ADDENDUM NUMBER 2
for
ADVANCED TREATMENT PROJECT
MEMORIAL PARKWAY TREATMENT PLANT
NORTHERN KENTUCKY WATER DISTRICT

FROM: CH2M HILL
 TO: Plan Holders of Record

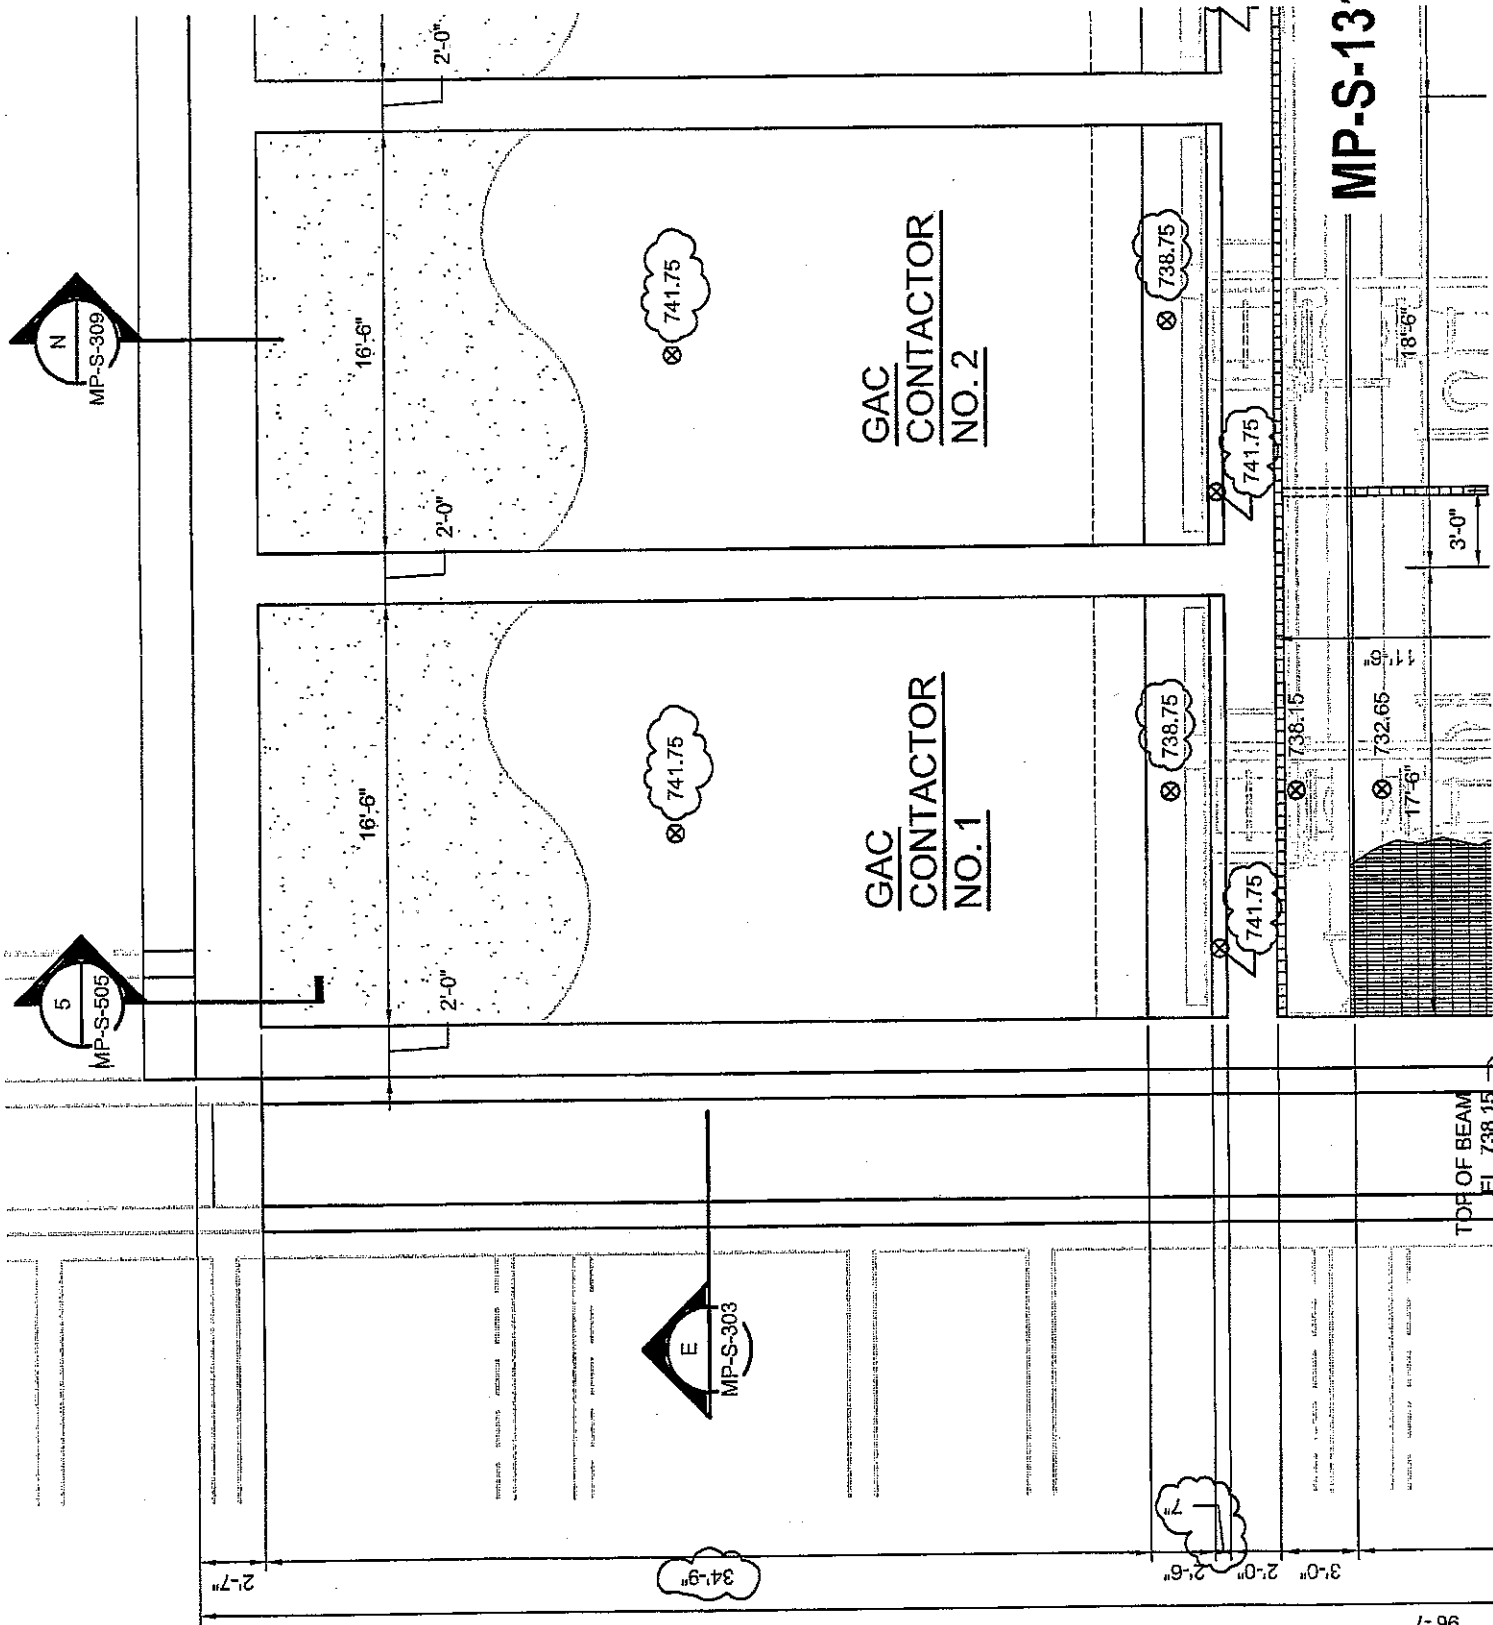
Revise the Drawing by modifying it in accordance with the attached sketch showing revised Contactor slab elevation of 741.75 and Effluent Backwash Inlet Flume (Gullet) elevation of 783.75. This change is typical for all six Contactors. Note 7" shelf adjacent to Effluent Backwash Inlet Flume not previously shown.
